ADDENDUM NO. 4

04/15/2026

YWCA OF GRAND ISLAND WYANDOTTE RENOVATION

315 WYANDOTTE ST

WYANDOTTE RENOVATION
YWCA OF GRAND ISLAND
315 WYANDOTTE STREET, GRAND ISLAND, NE

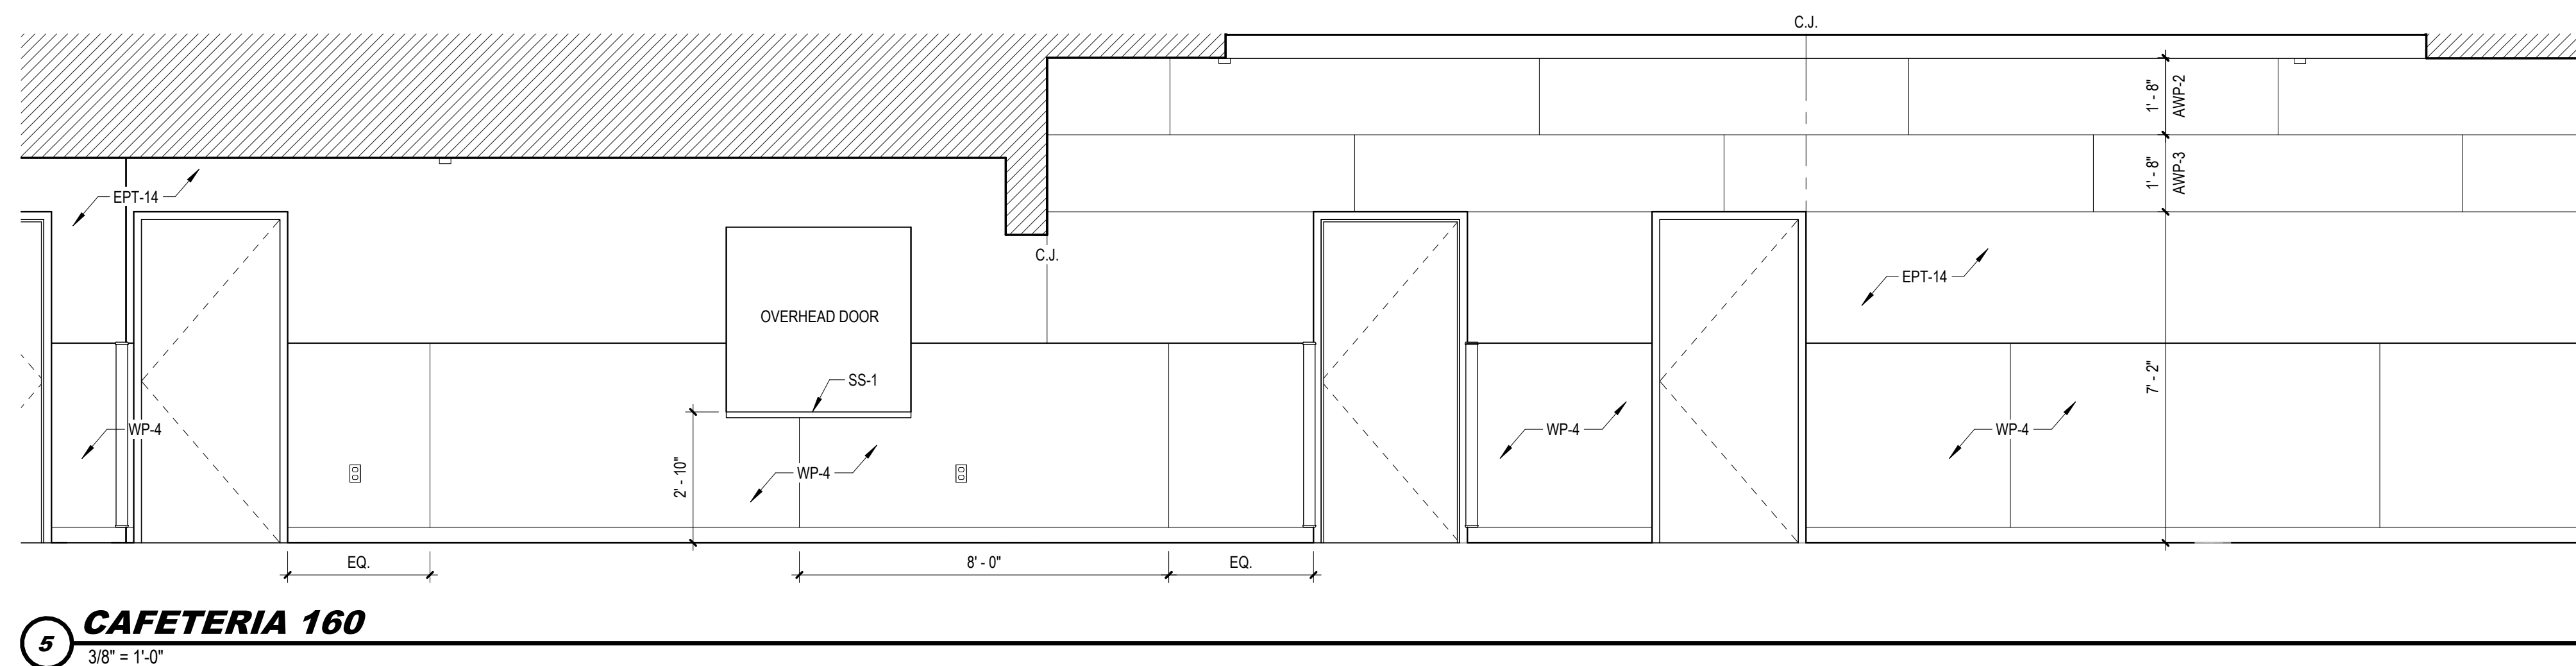
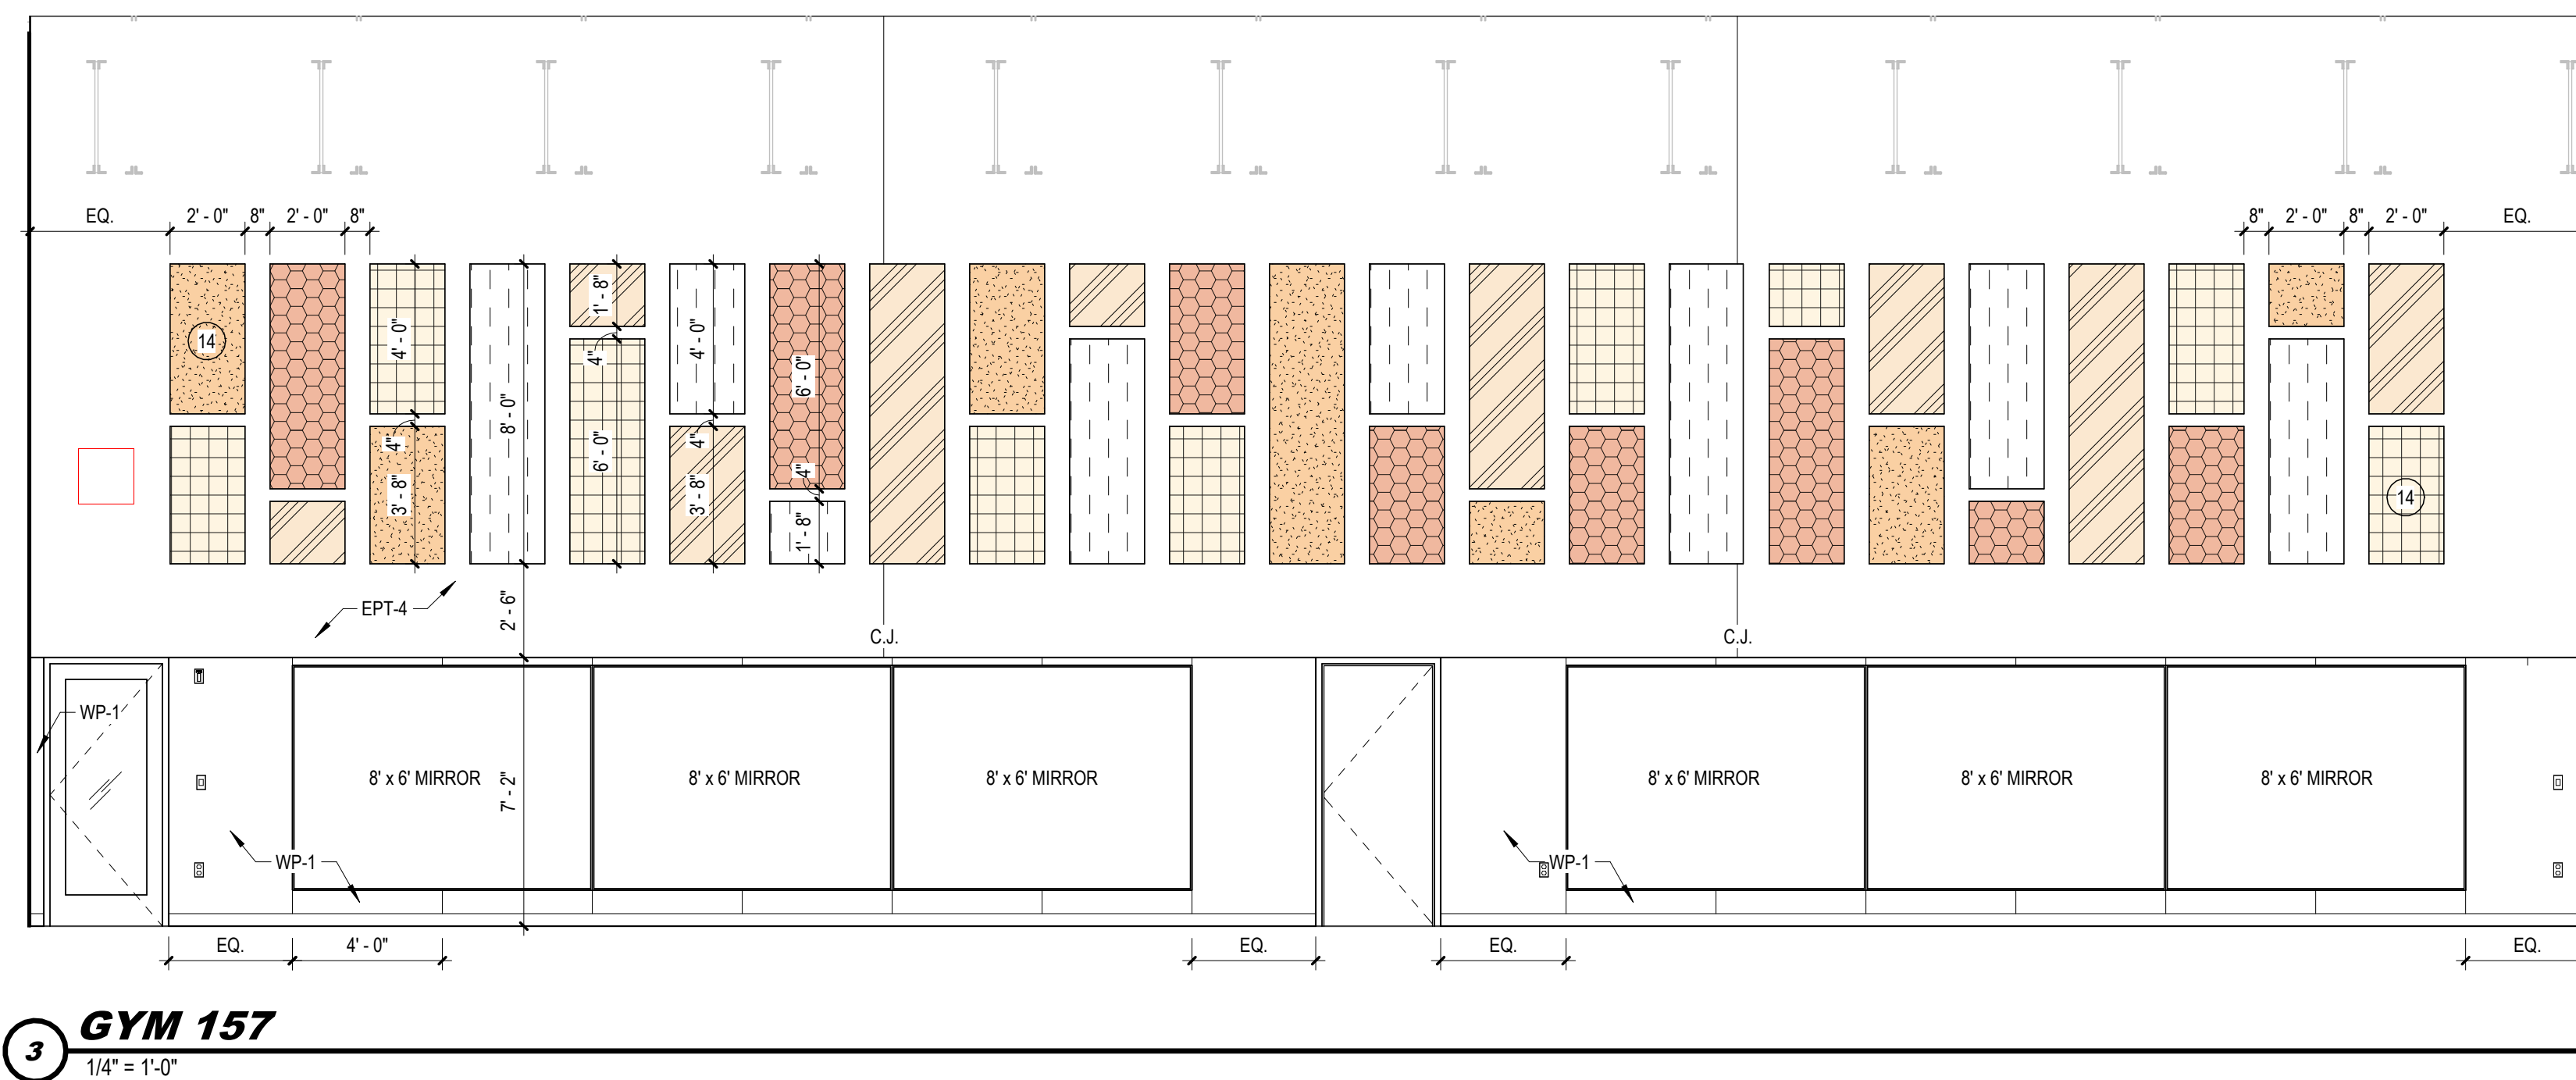
SHEET A6.05 - INTERIOR ELEVATIONS - CHILDCARE

1. Sheet MD1.00 First Floor – Plumbing Demolition Plan
 - a. See sheet MD1.00 for changing of (2) sheet note #30 to sheet note #2 and (1) sheet note #2 to sheet note #30.

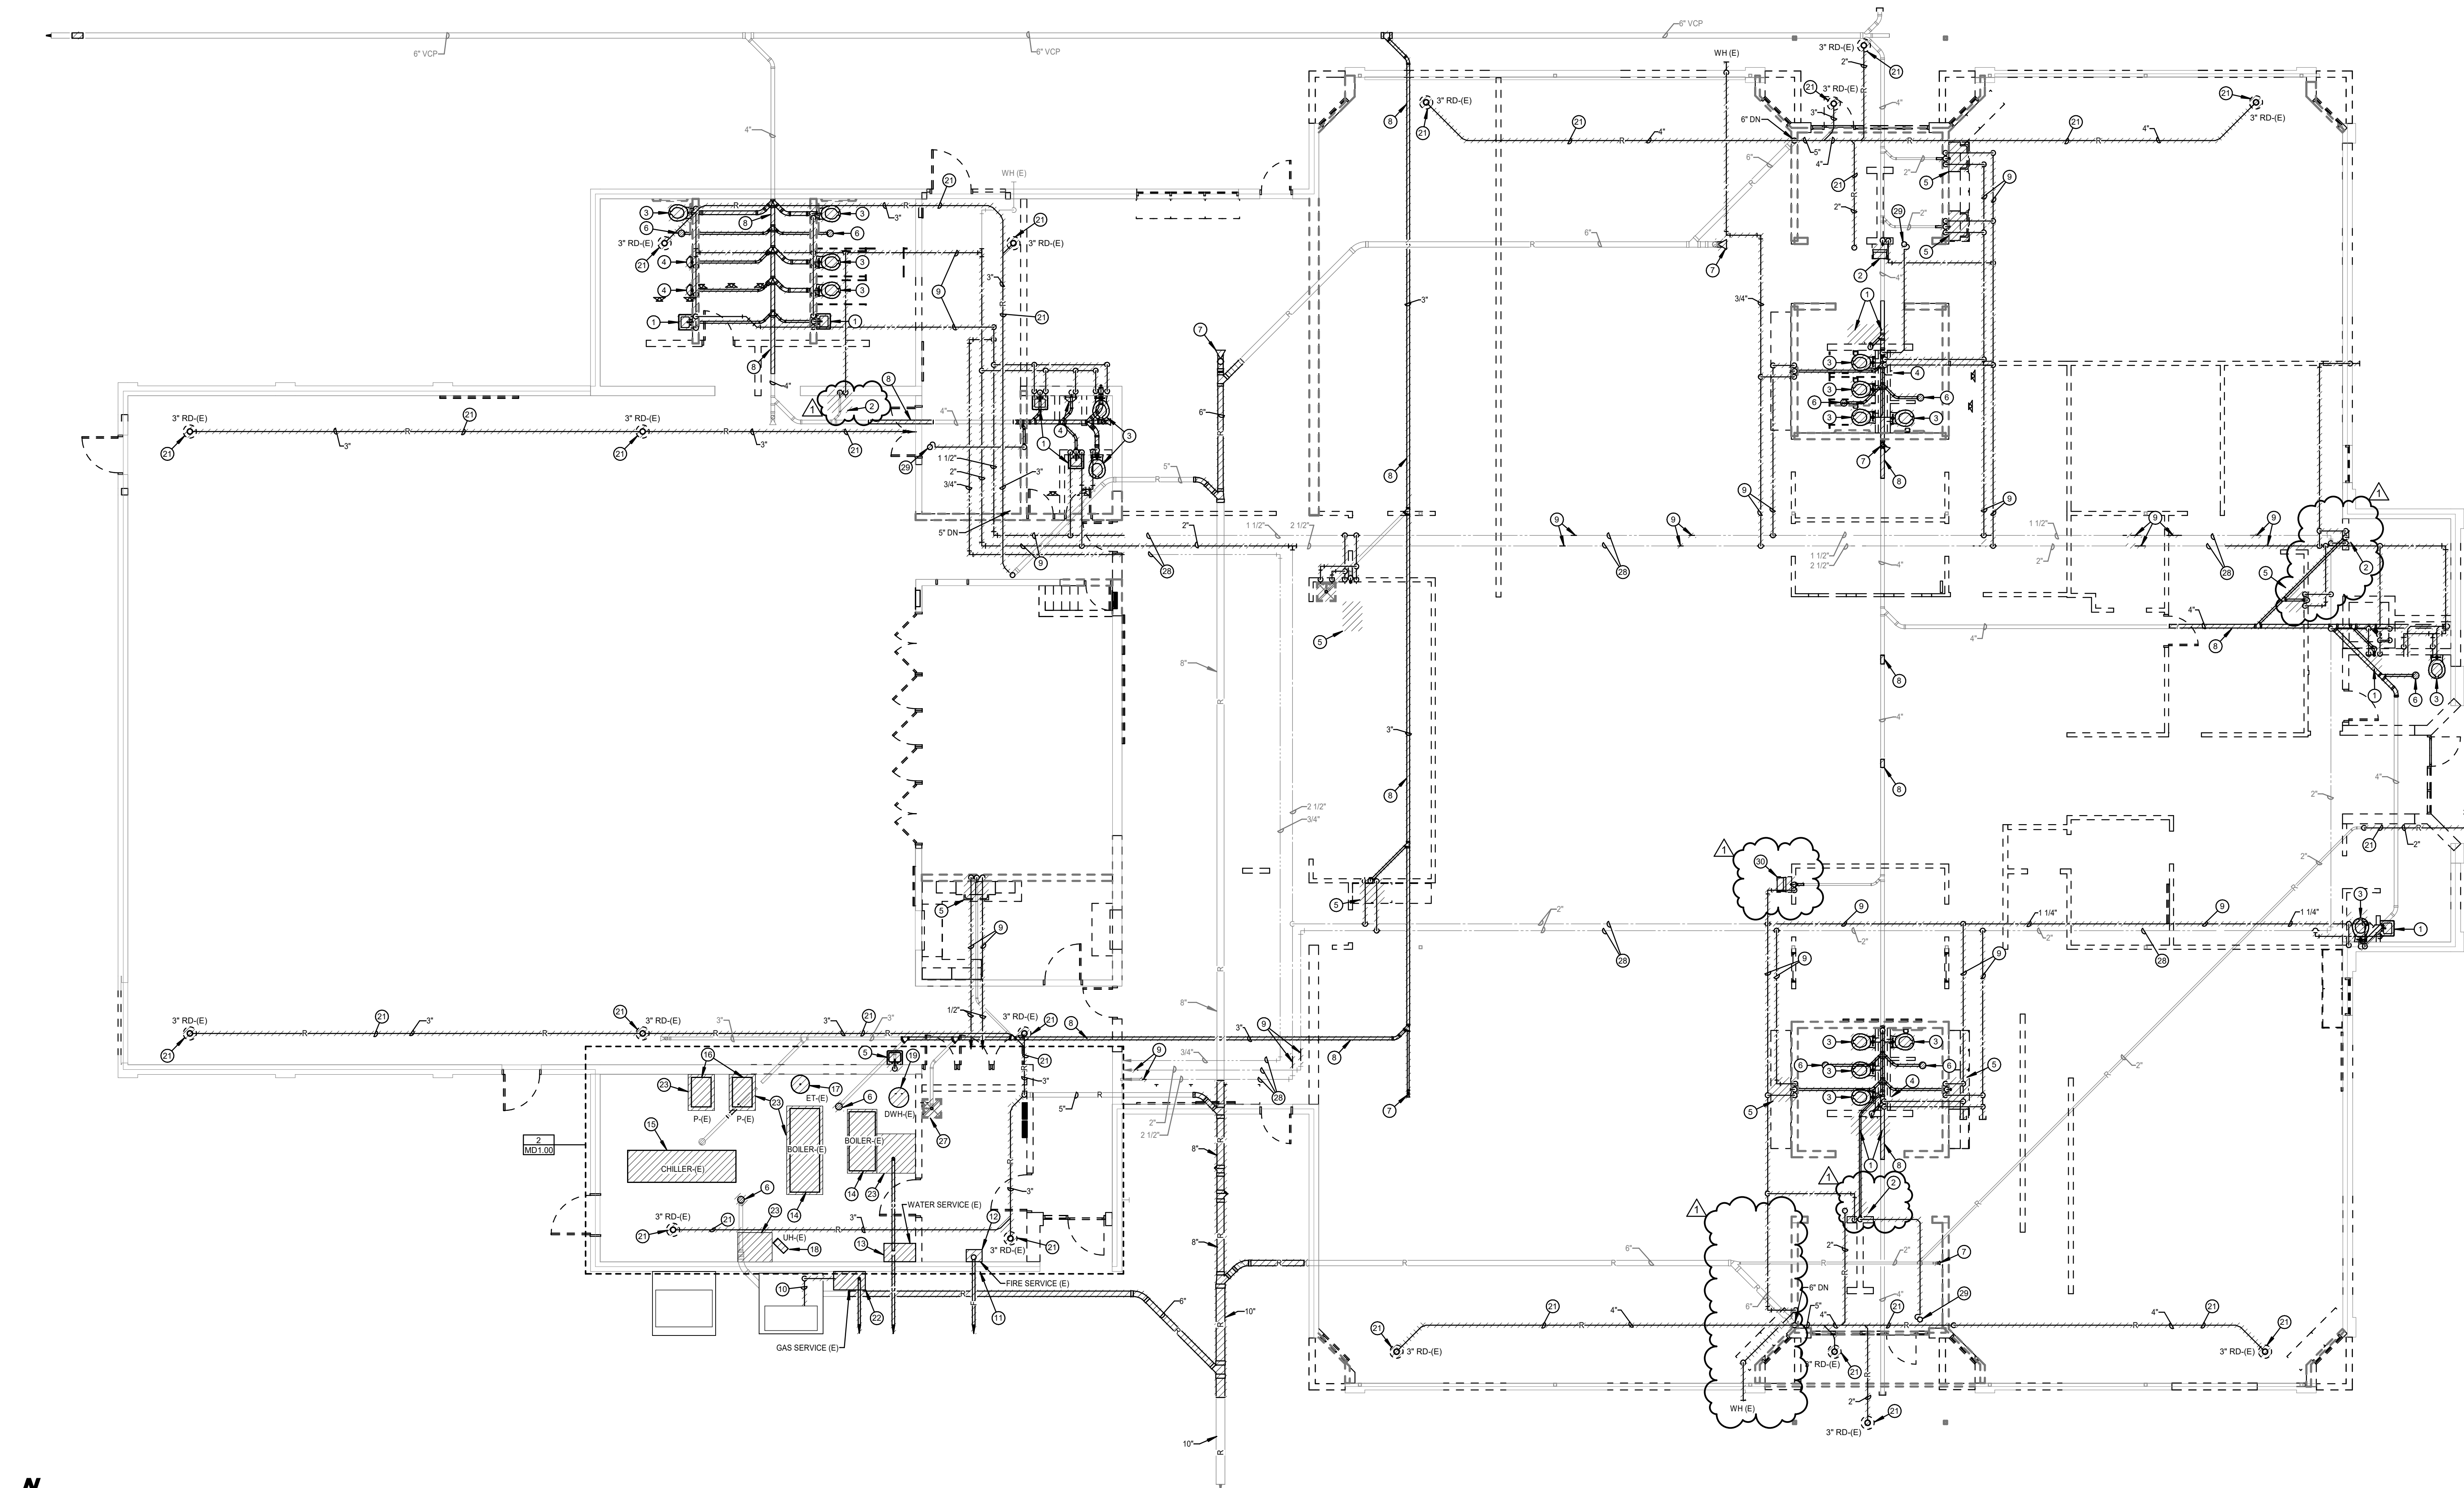
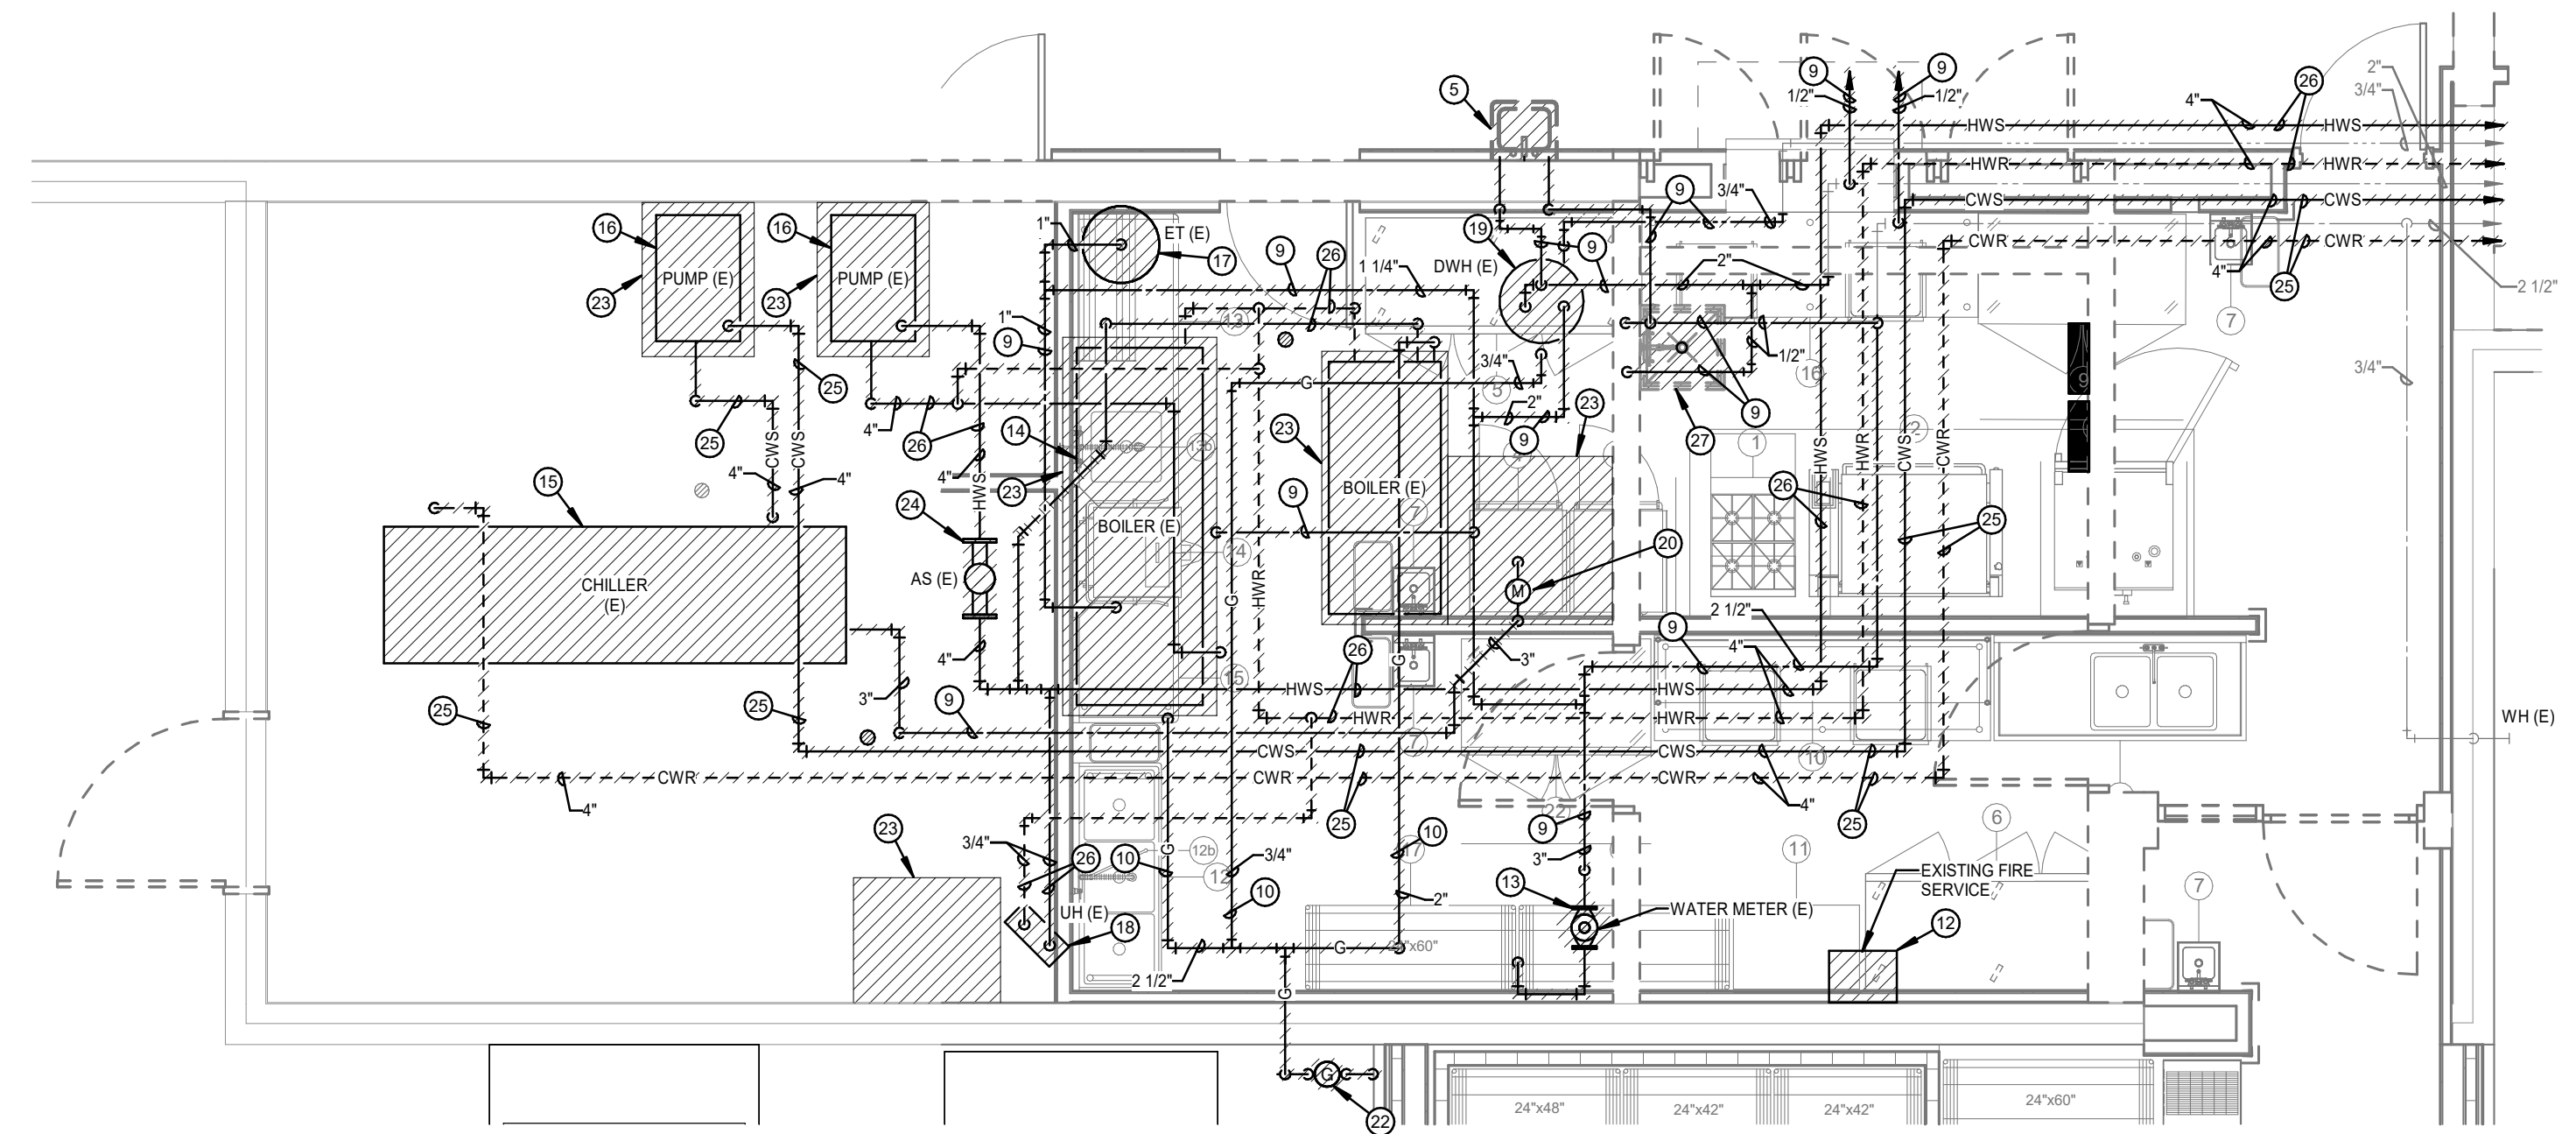
- b. See sheet MD1.00 for removal of sanitary and domestic water piping from existing sink that had previously been removed.
 - c. See sheet MD1.00 for relocation of domestic cold water piping from existing wall hydrant (WH-(E)).

- 30 REMOVE SINGLE ELECTRIC WATER COOLER WITH BOTTLE FILLER AND WALL MOUNTING PLATE. RELOCATE WATER COOLER TO NEW LOCATION. CAP EXISTING WATER AND DRAIN BEHIND WALL. SEE SHEET M1.00 AND M1.01 FOR NEW LOCATION NEAR GYM.
